ARCHITECT'S SUPPLEMENTAL INSTRUCTIONS

PROJECT:	The Reserves at Magnolia New Apartment Complex Denton, TX	Report No.	One (1)
OWNER:	Overland Property Group Dan Maximuk 234 N. Santa Fe Ave, Suite A Salina, KS 67401	Date	Oct. 22, 2024
CONTRACTOR:	Snyder Construction Group 4820 N. Town Centre Dr. Ozark, MO 65721	Architect's Proj No.	21-3205
		Contract For:	General Construction Mechanical, Electrical

Please Note: Drawings and Specification Edits associated with this ASI are dated as **7-17-2024**. This date above is the date this ASI was issued.

A2.1

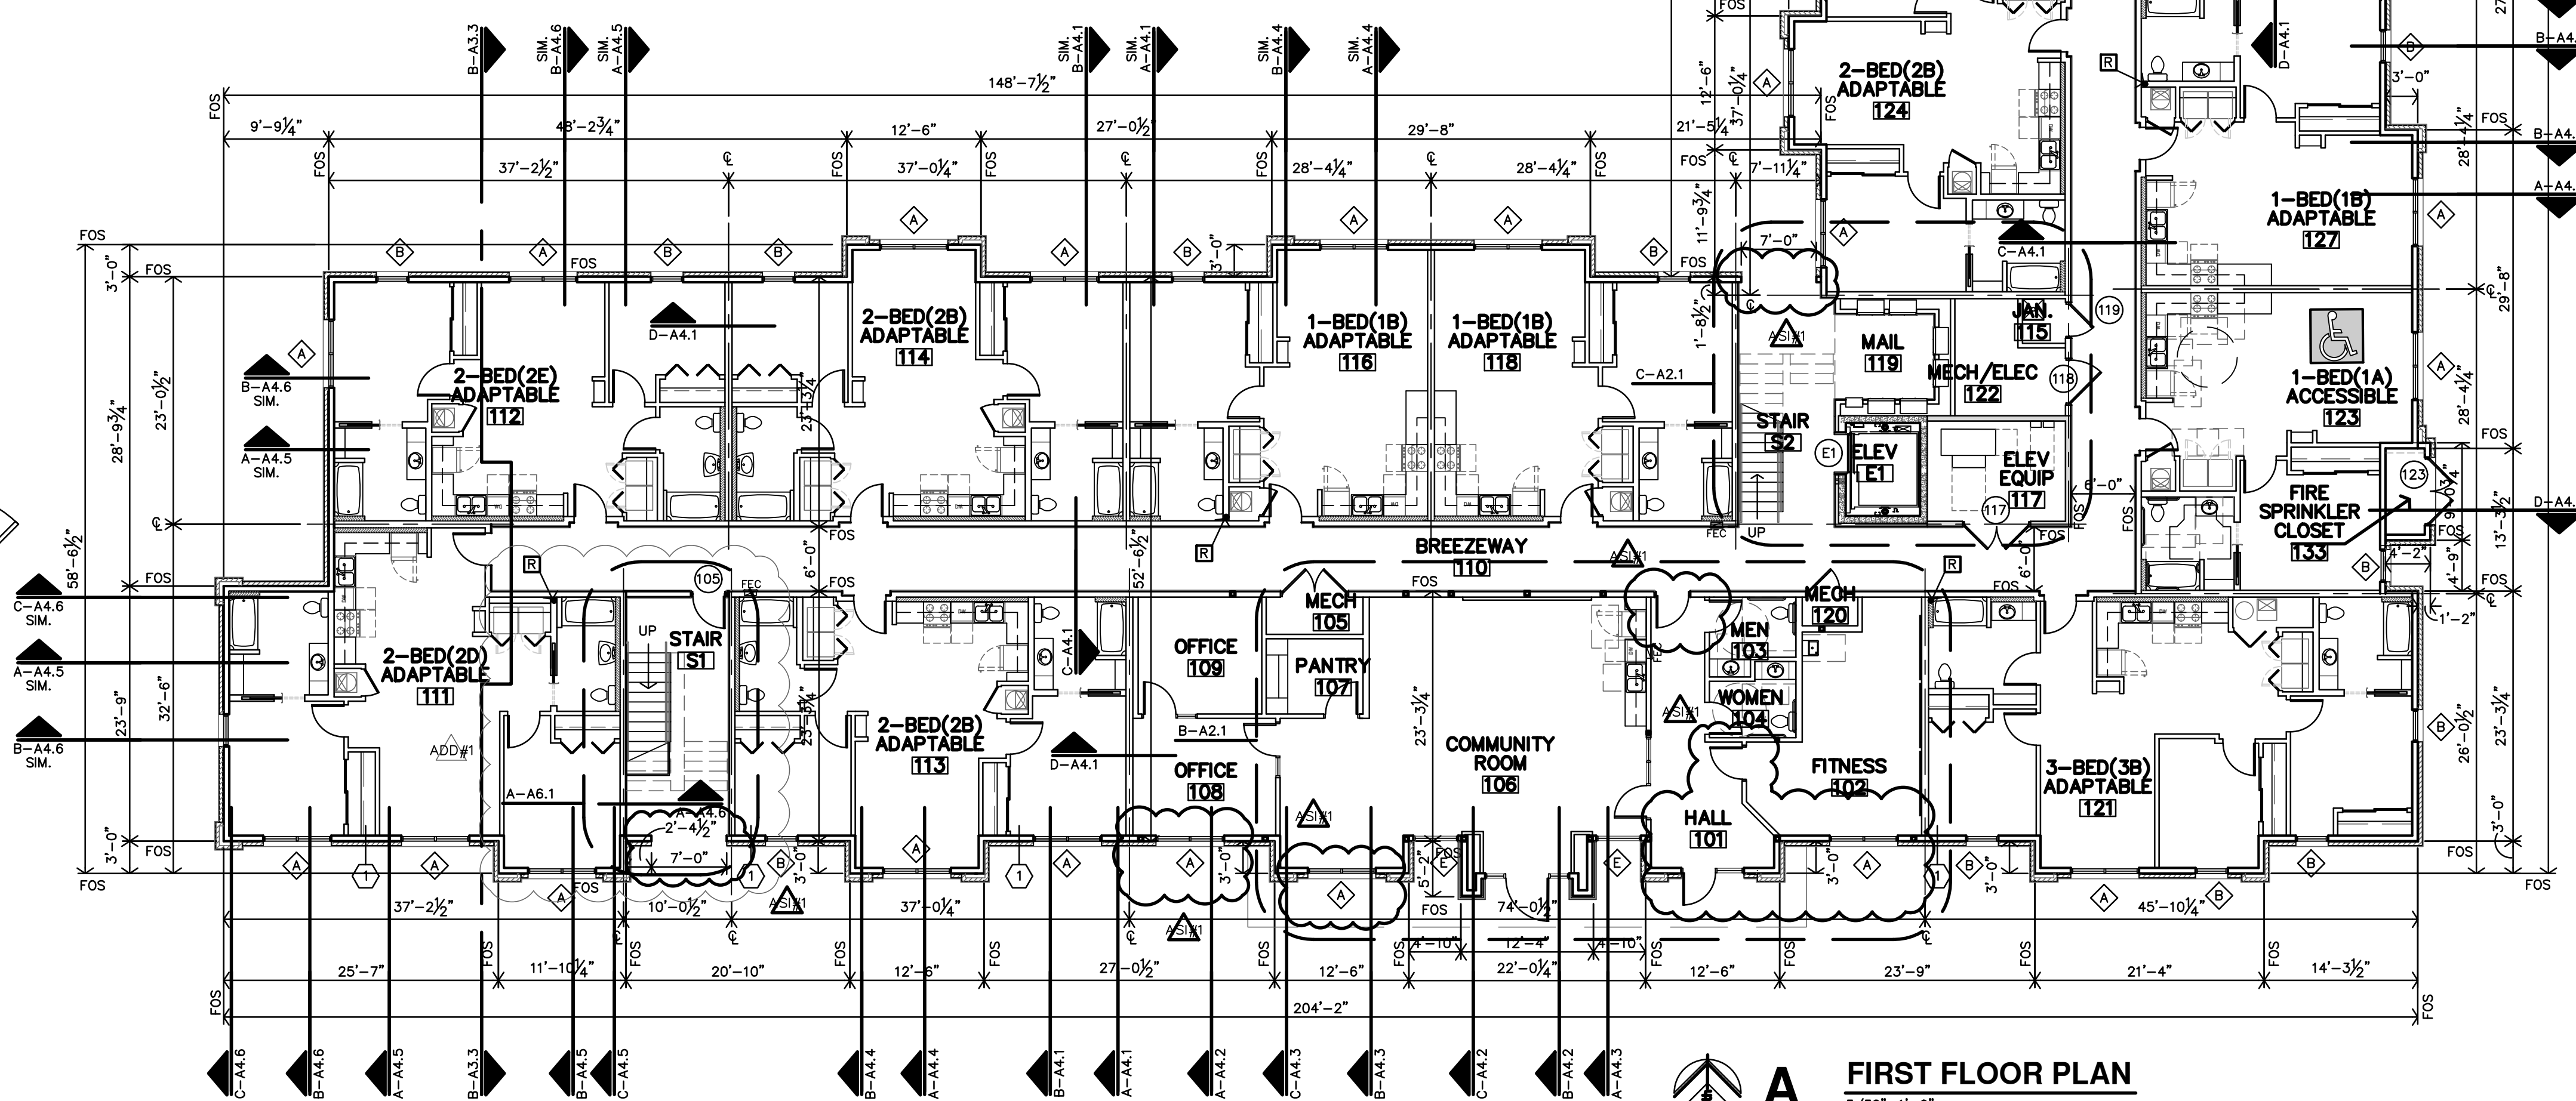
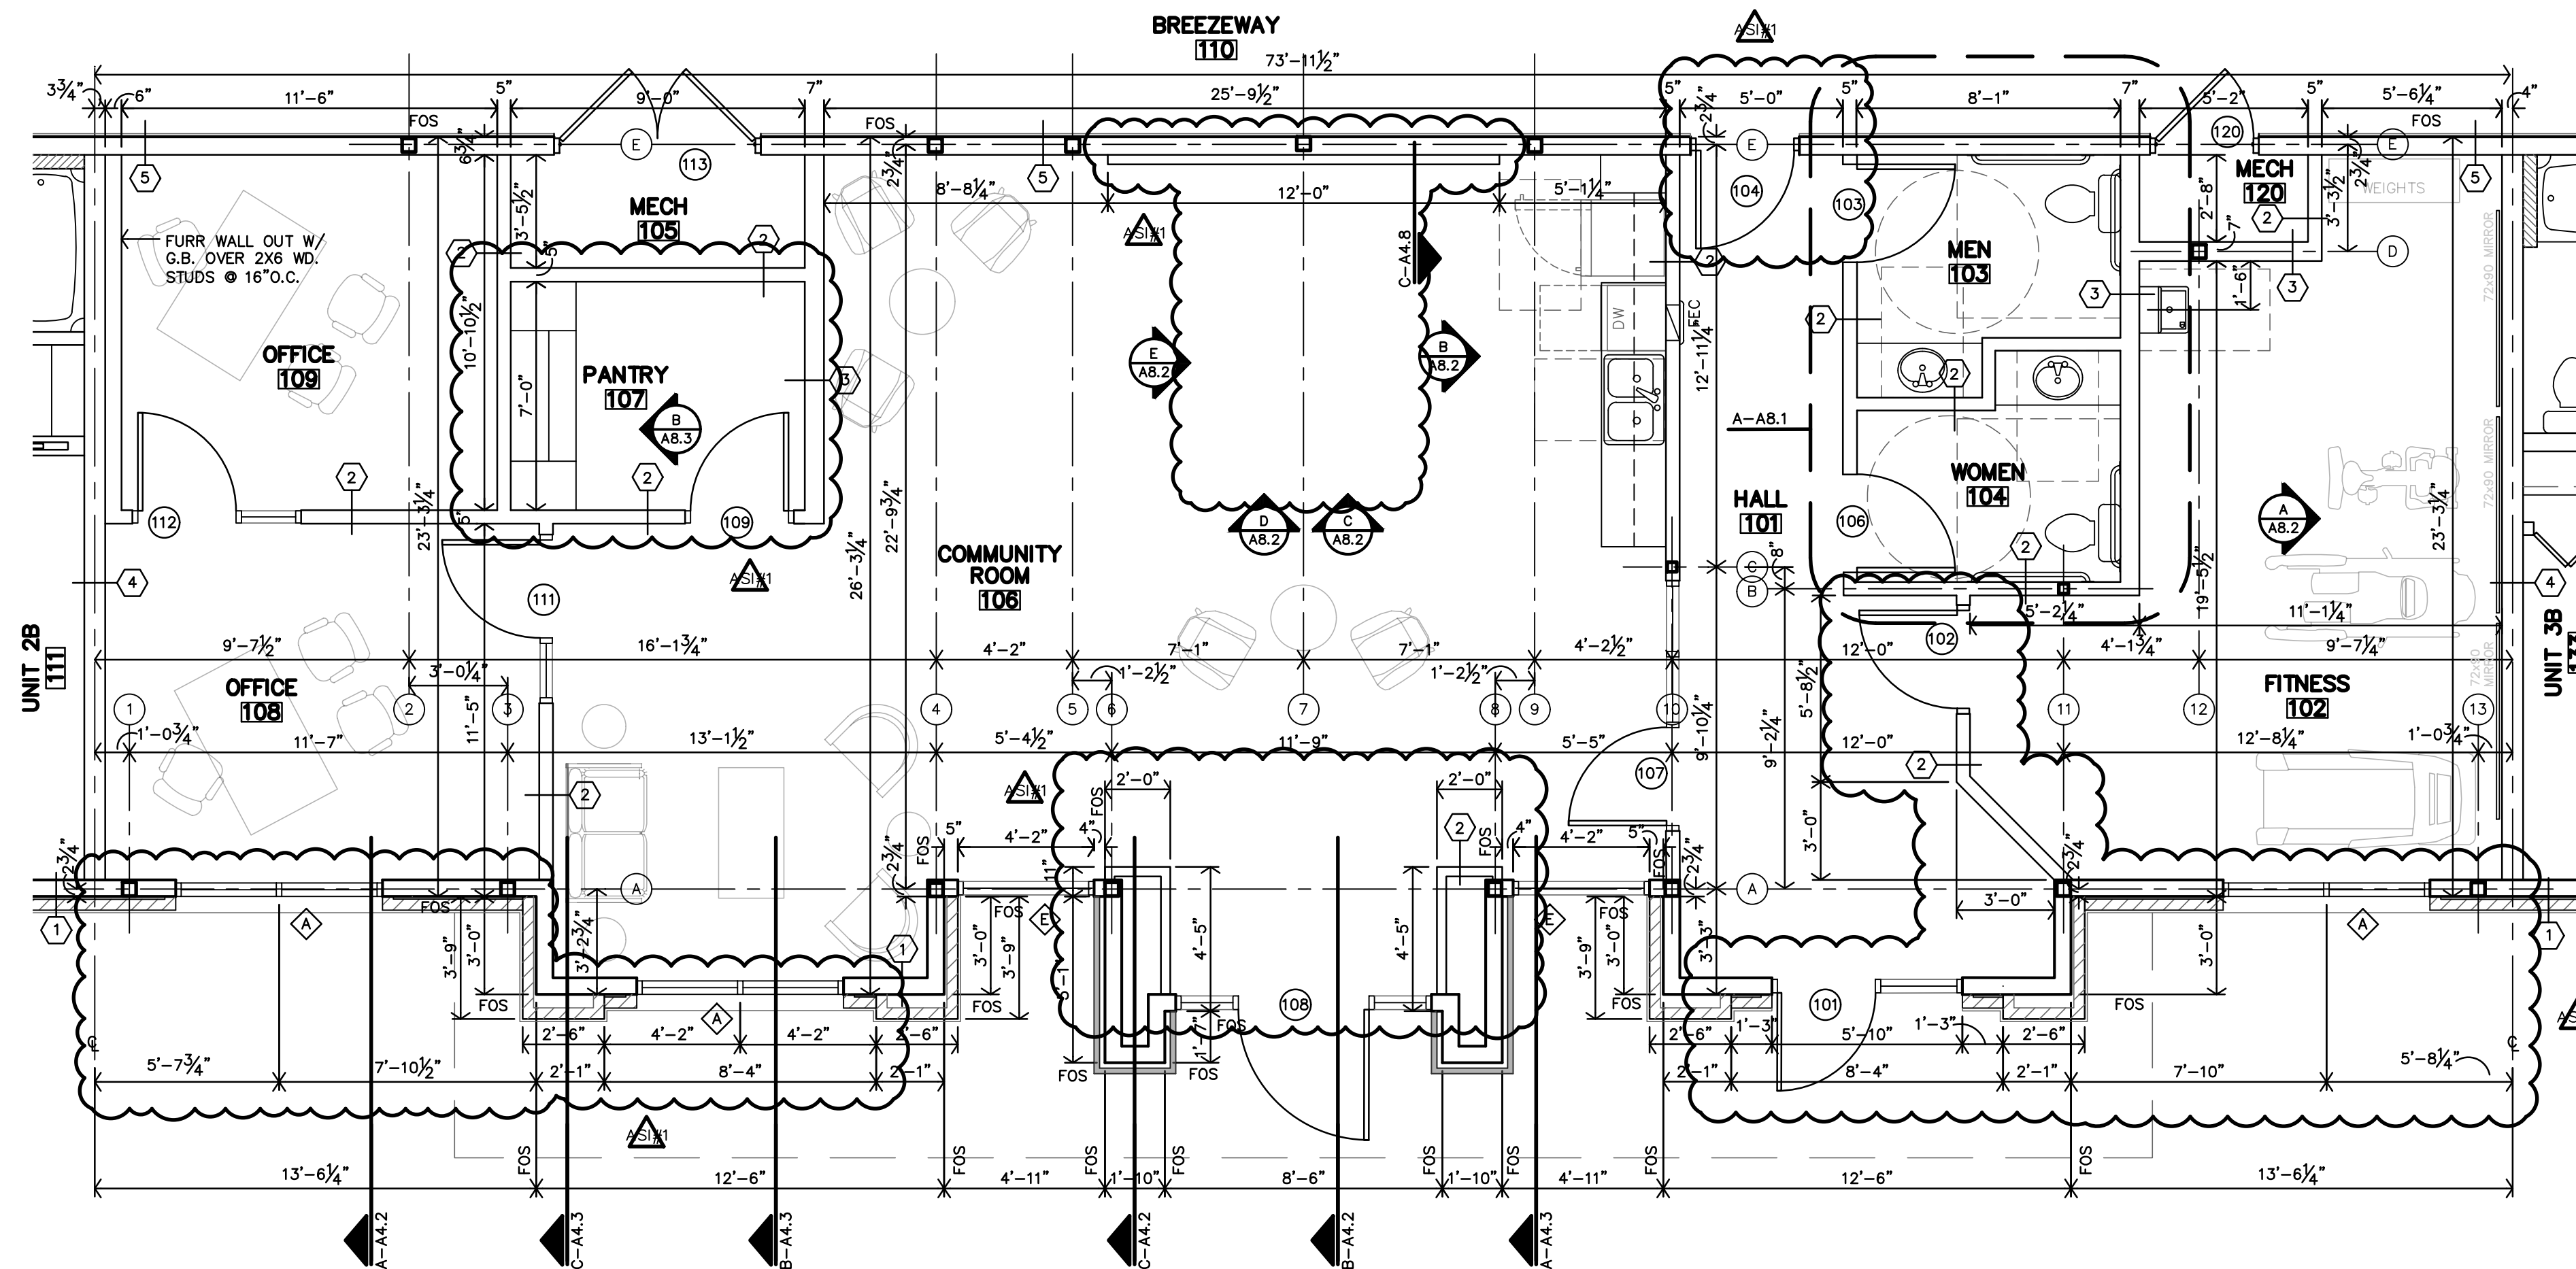
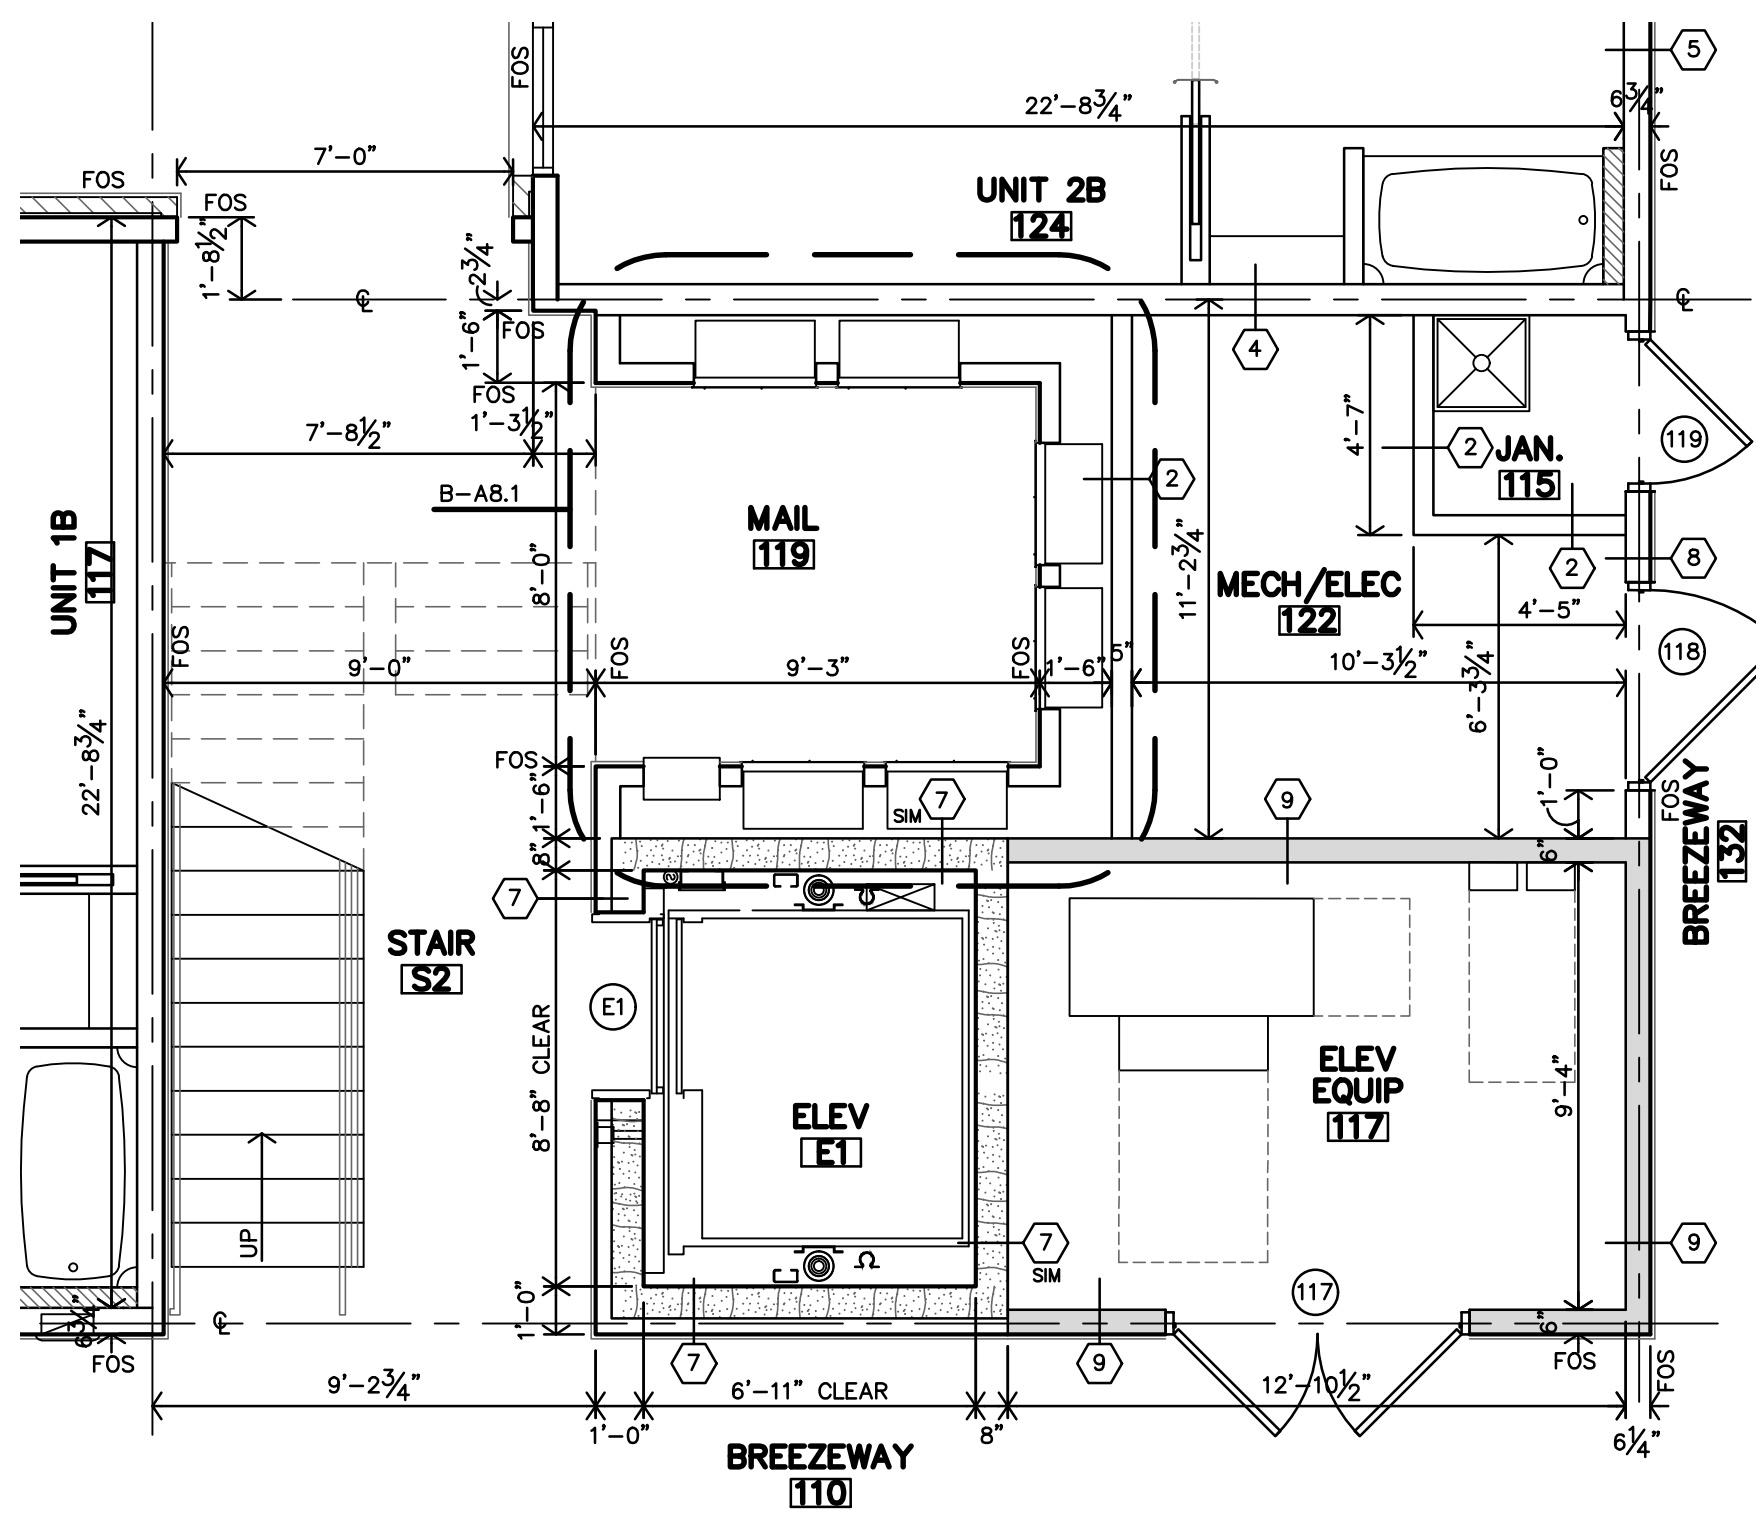
- 6) Omit all interior thin pre-cast panels at Community Room #106 - accent wall, and the entry vestibule area. (VE Item #9)
Reference Revised plans and details on Sheets A2.1, A4.2, A4.8 and A8.2.

- 8) Utilize 5/8" OSB Roof deck sheathing in lieu of the specified 3/4" Zip System Roof Sheathing. (VE Item #11)
- 9) Casework in Food Pantry #107 has been reduced and reconfigured. (VE Item #12). Reference revised plan on Sheet A2.1 and revised details on Sheet A8.3.

- 17) Omit Security Gate and Doors #114, #116, #121 and #122. (VE item #22). Reference revised plans and details on Sheets A2.1, A3.1, A3.2, A6.1, A6.2 and A10.2.

- 38) Reduction in Storefront (VE Item #44) Reference revised Sheets A2.1, A3.1 and A10.2
 - a. Omit Storefront Windows C & D, replace all with Window A.

- 40) Omit all individual unit water submeters from the project. (VE Item #47). Reference revised sheets P5.2 and P5.3
- 41) Omit the island casework in Community Room #106. (VE Item #48). Reference revised plans and details on A2.1 and A8.2.
